Clover Creek Solar Project LLC d/b/a New Frontiers Solar Park
Second Set of Supplemental Responses to Siting Board Staff's First Request for Information
Case No. 2024-00253

Request No. 15:

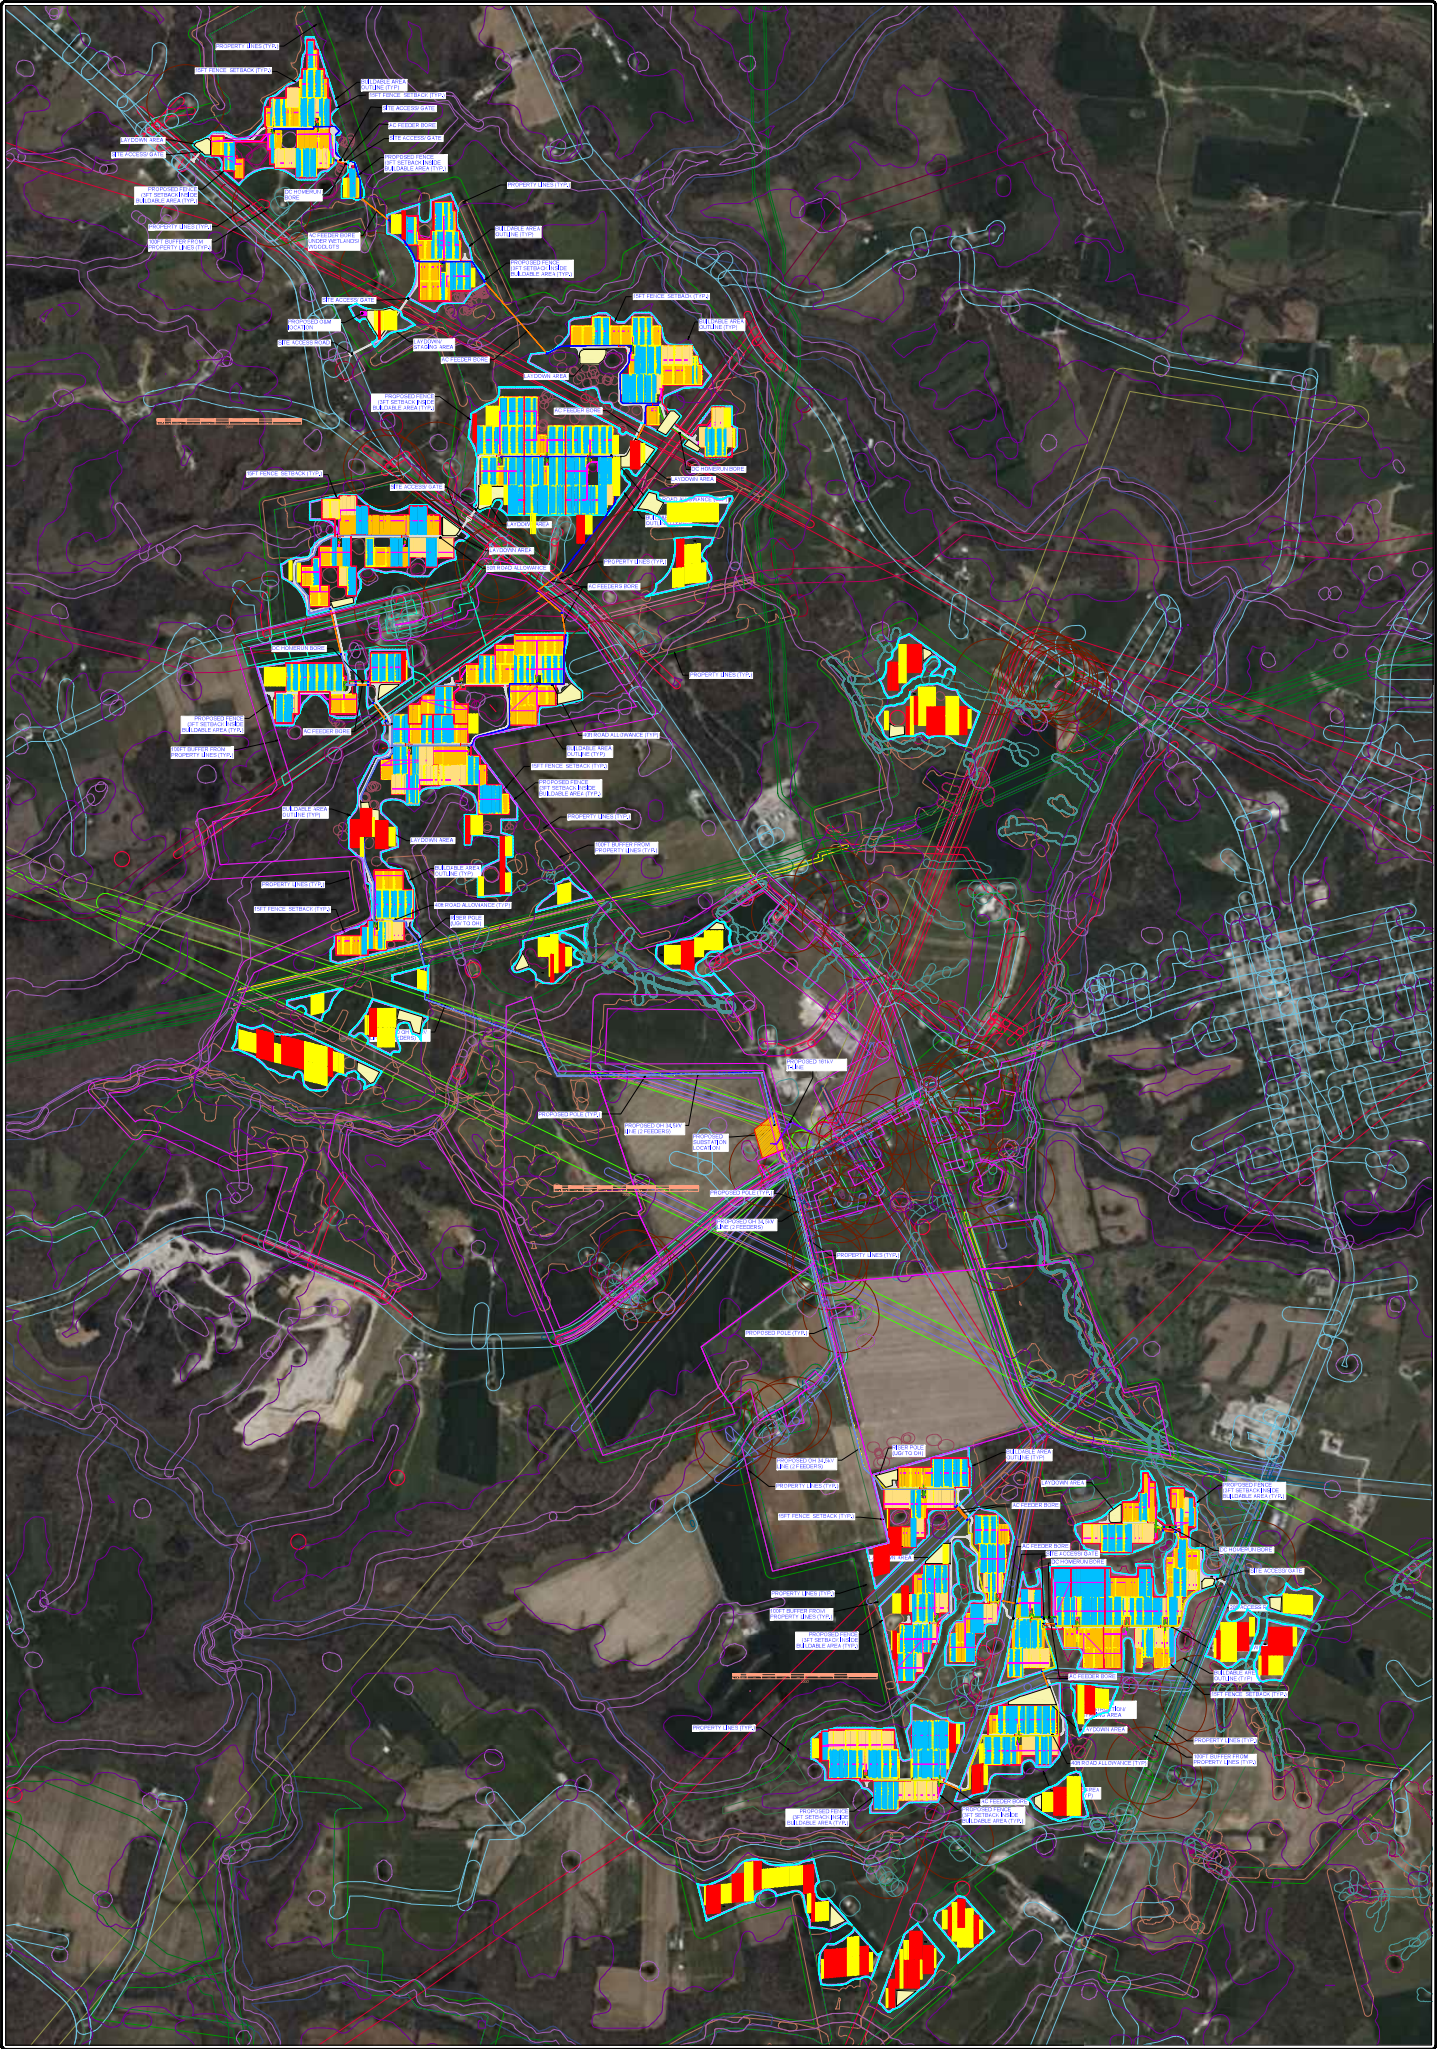
Refer to the Site Assessment Report (SAR), Attachment A, Preliminary Site Layout. The map that is provided is not legible. Provide an updated site plan for the proposed project that is of sufficient quality. Separate the site plan into discrete project areas and file the documents separately so each one can be accessed and enlarged.

Please see the attached updated SAR Attachment A.

Please see attached updated SAR Attachment A, revised to remove parcels 59-8 and 59-15.

Engineering Map

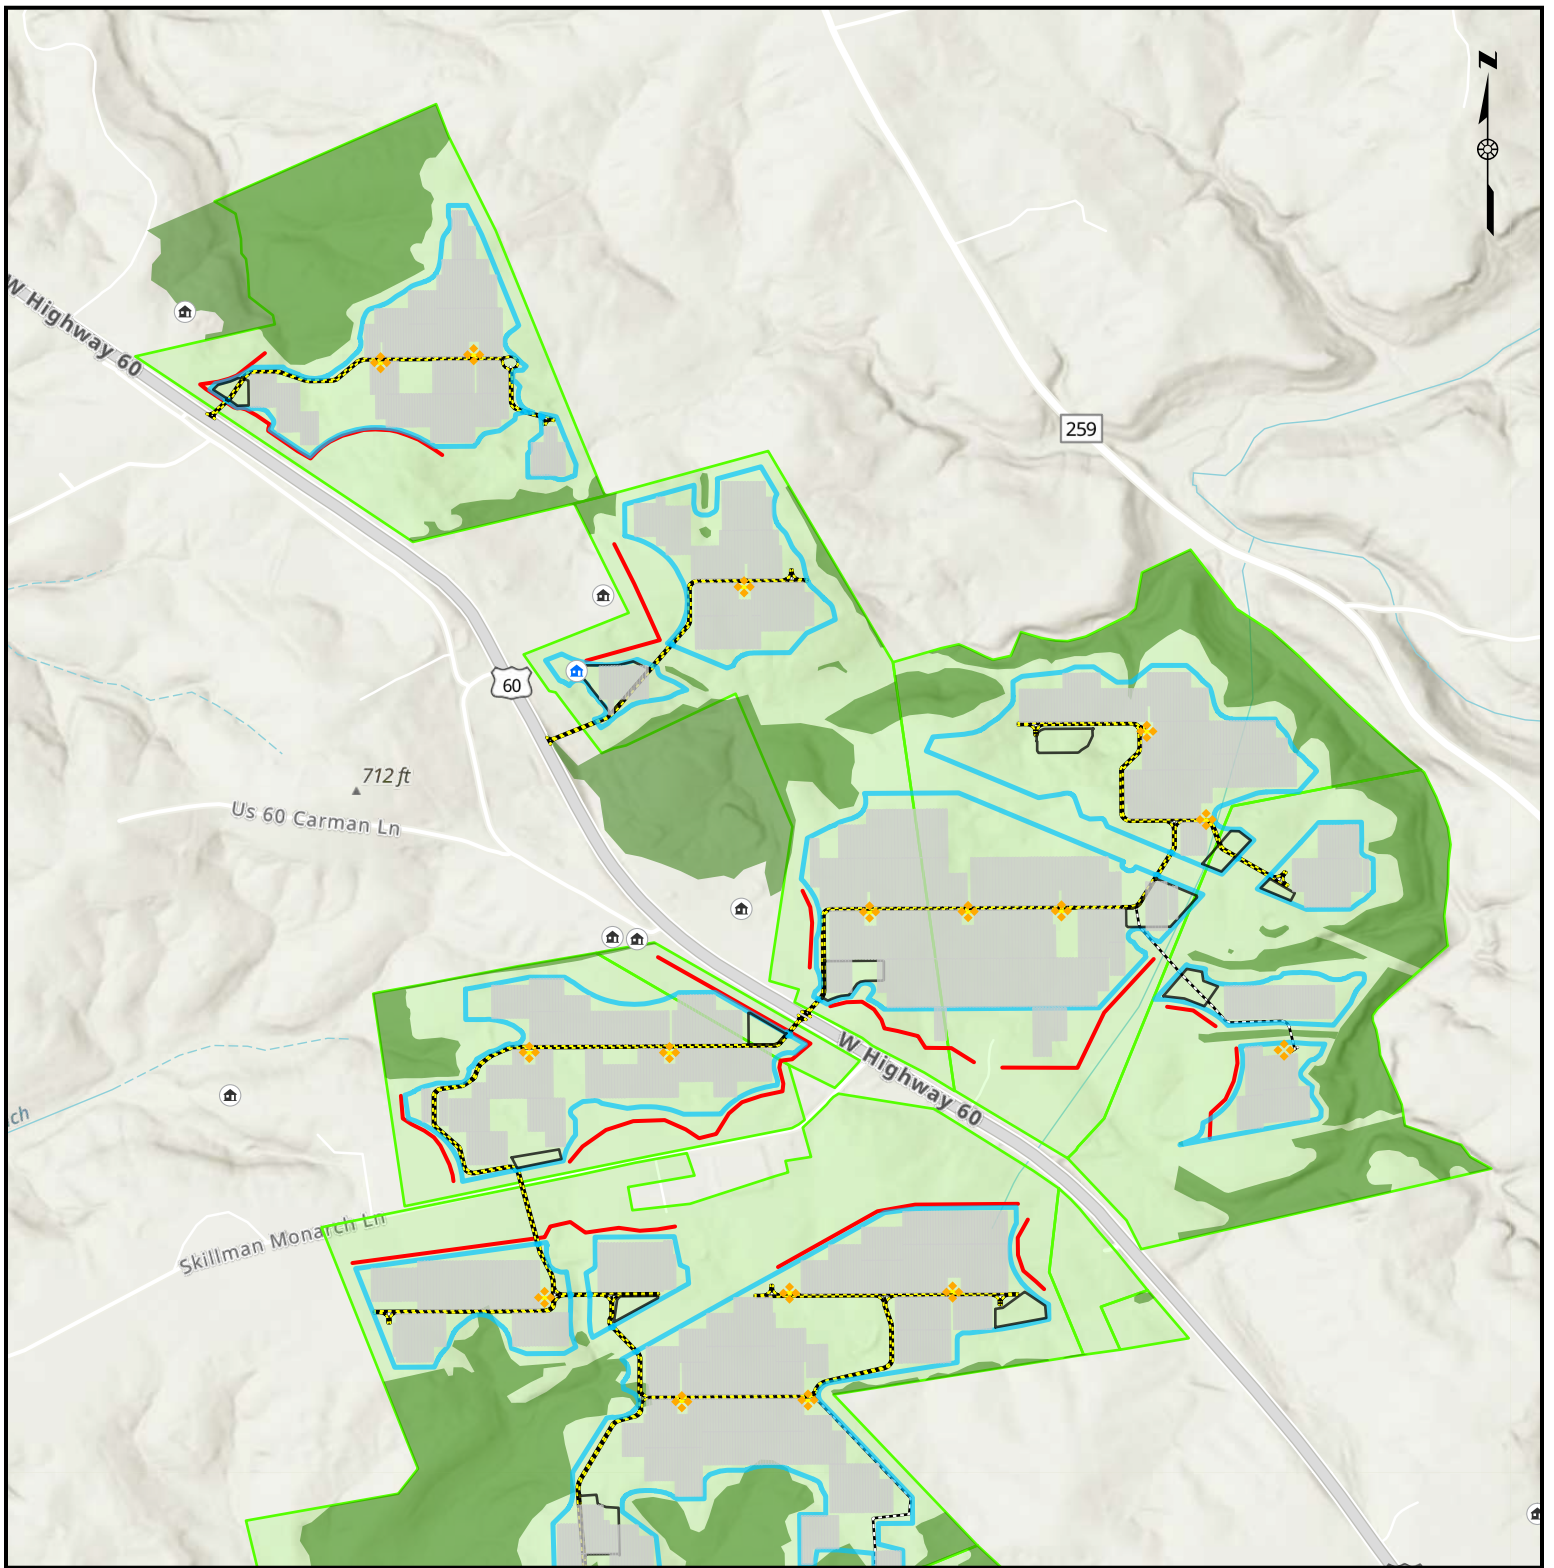
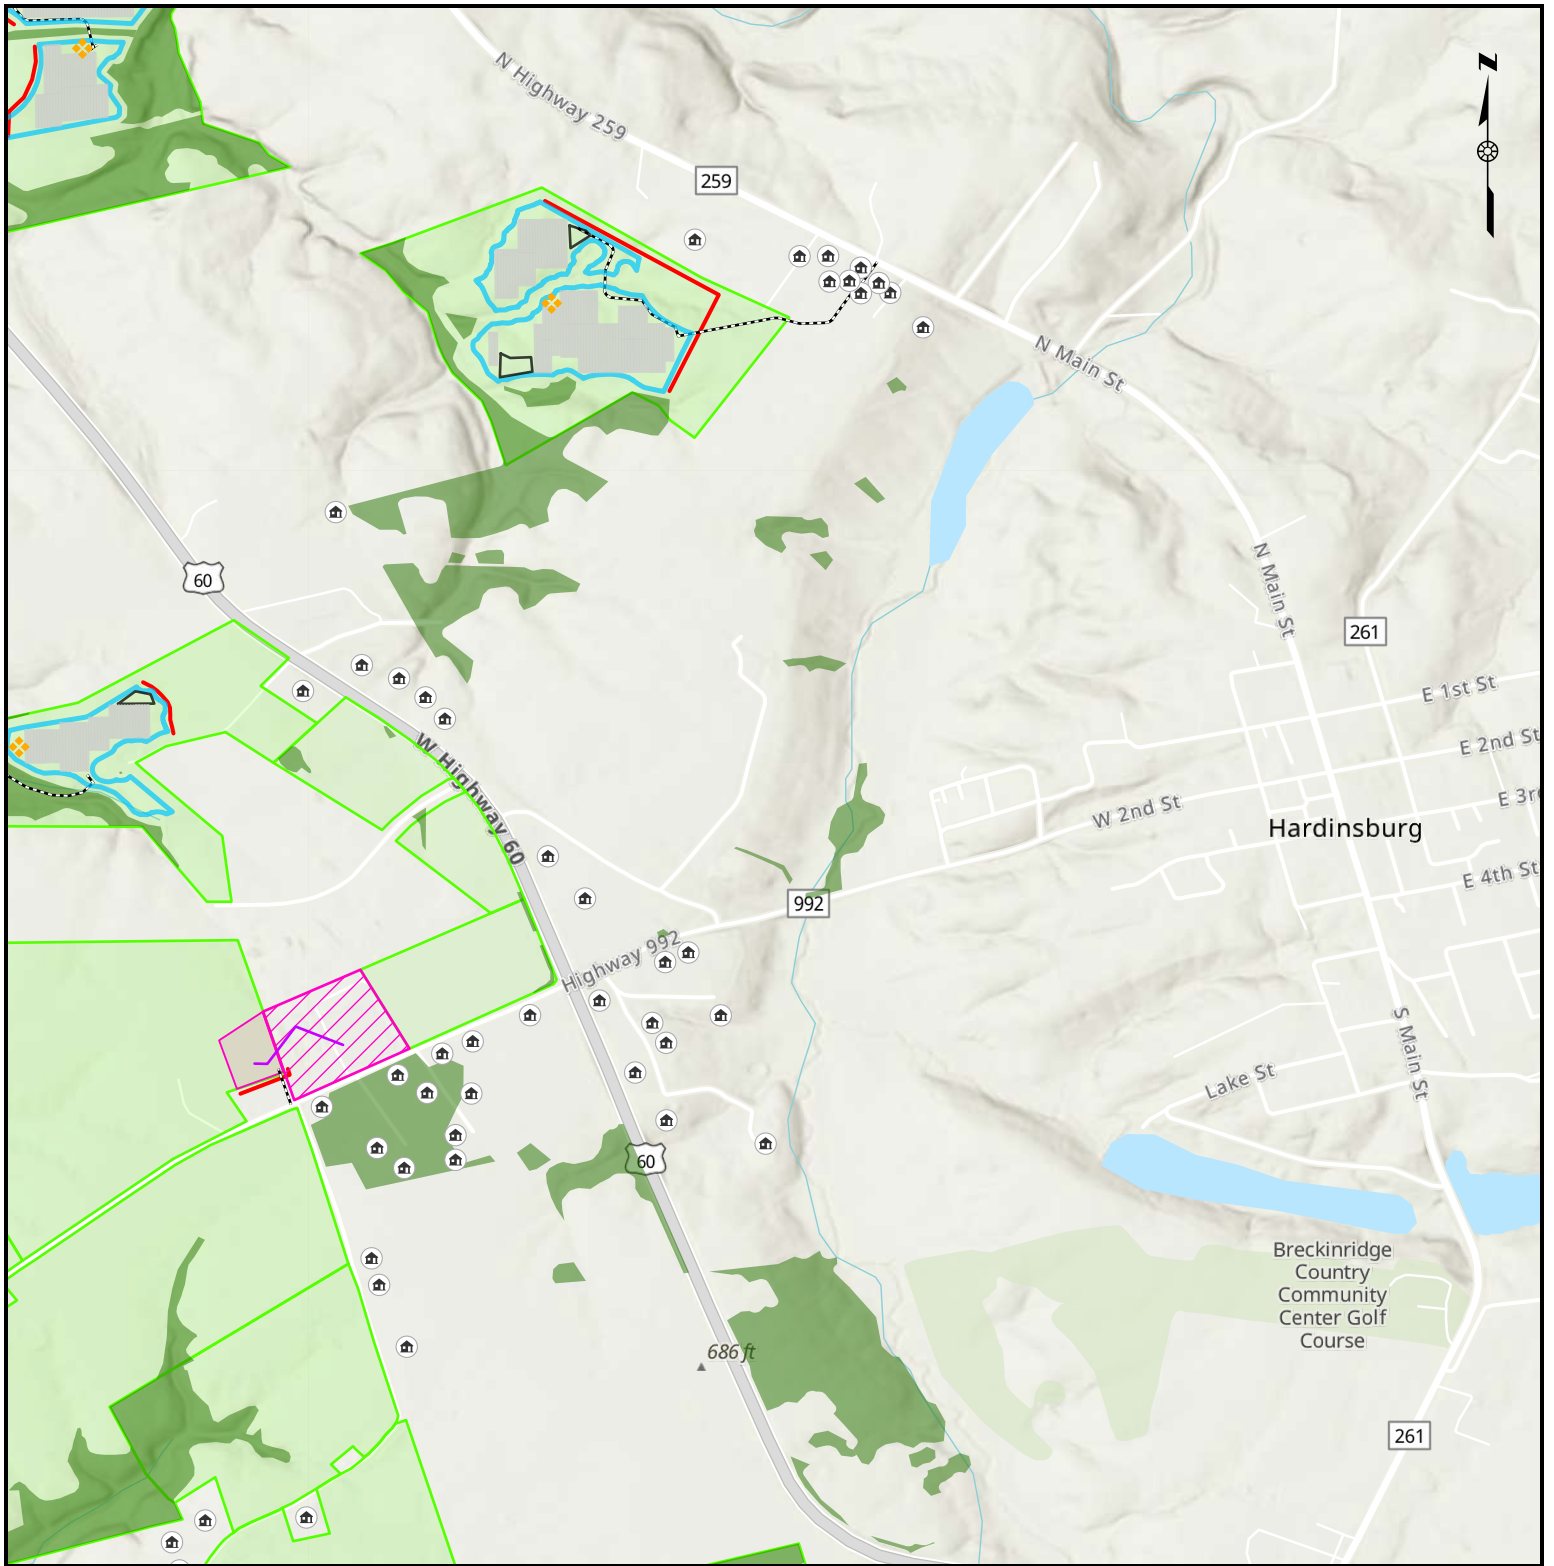
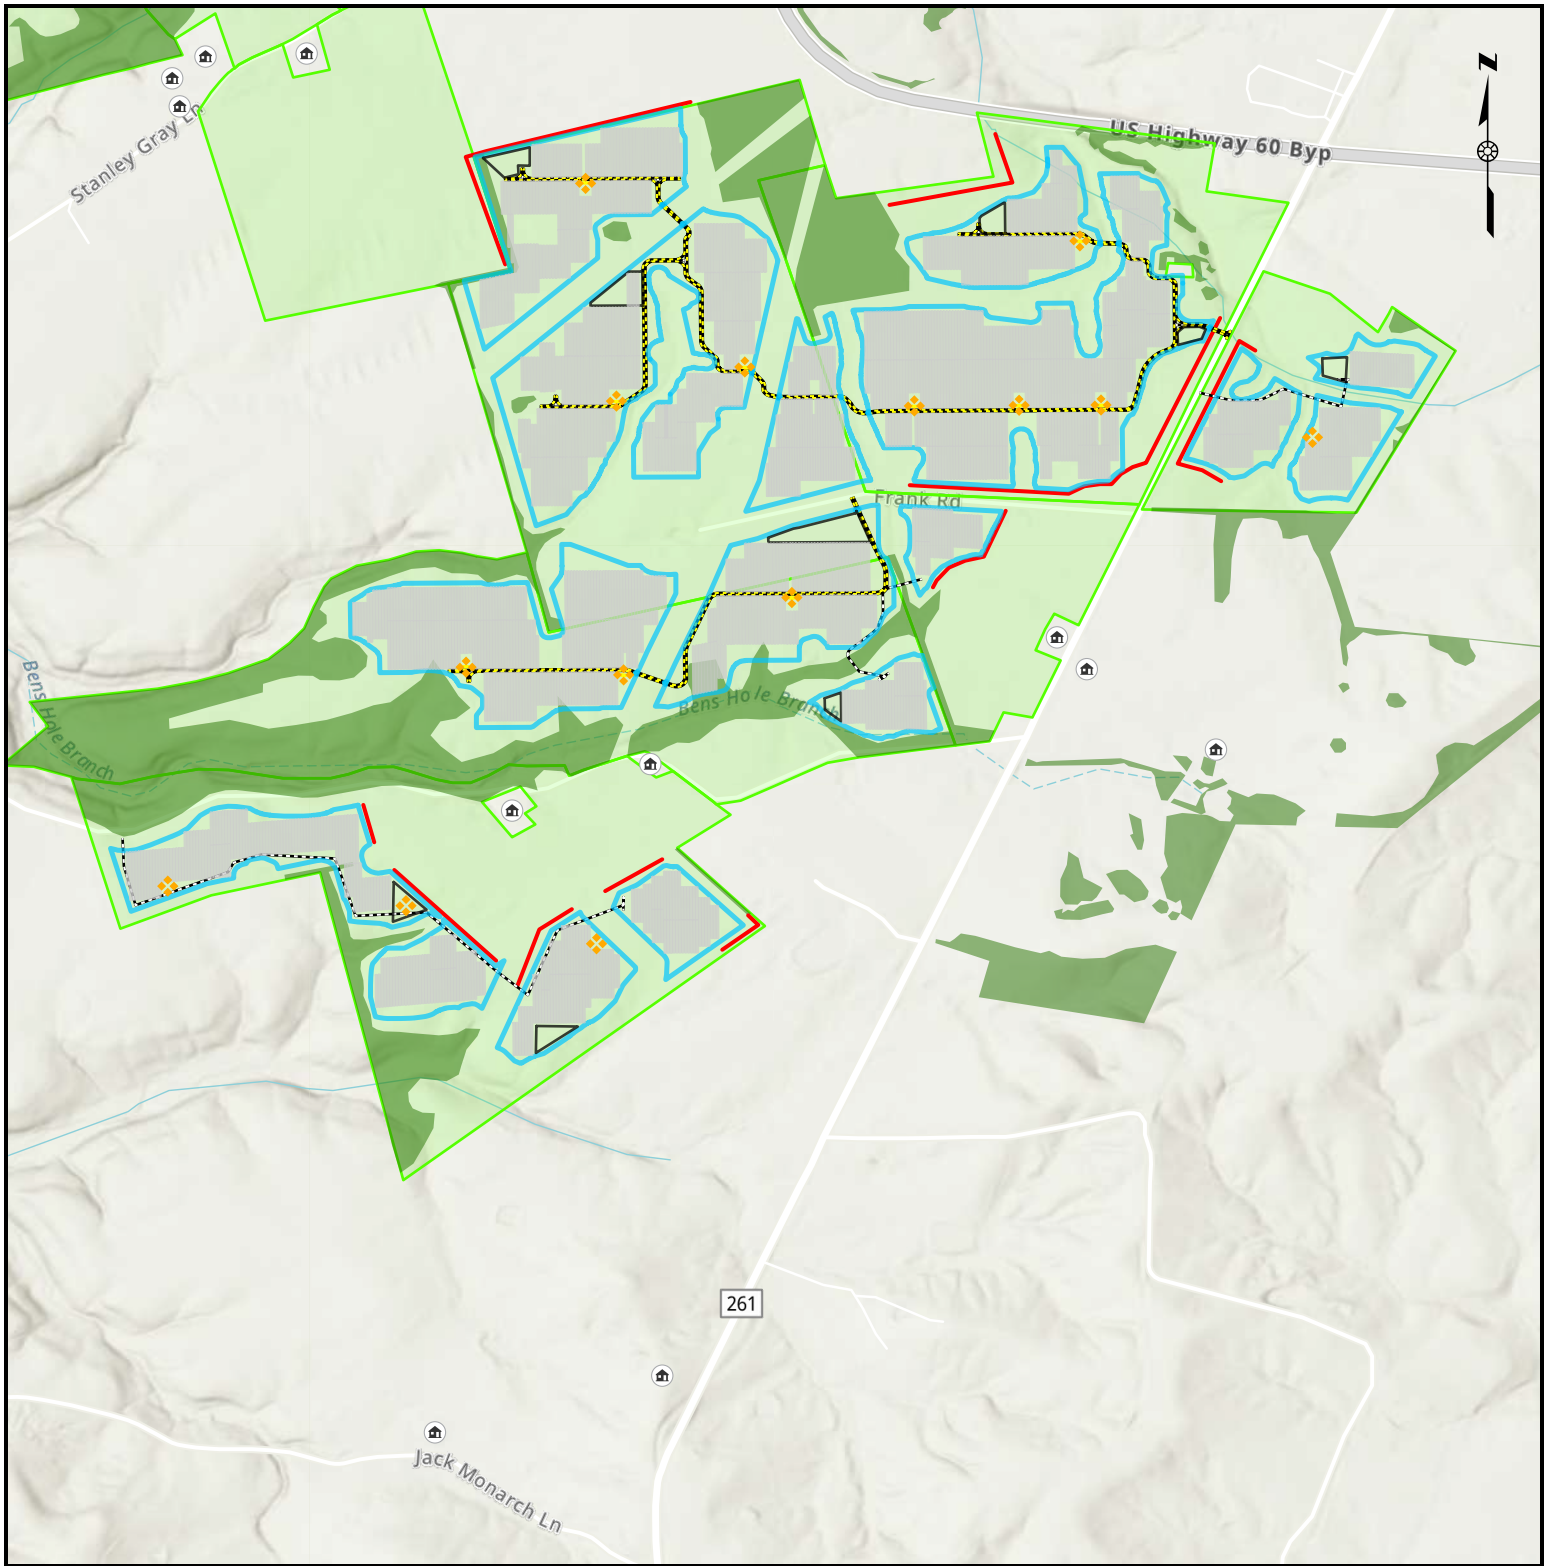
Provide a map highlighting all construction entrances to the Project site and all roads proposed to be used.

Supplemental Response to Request No. 42:
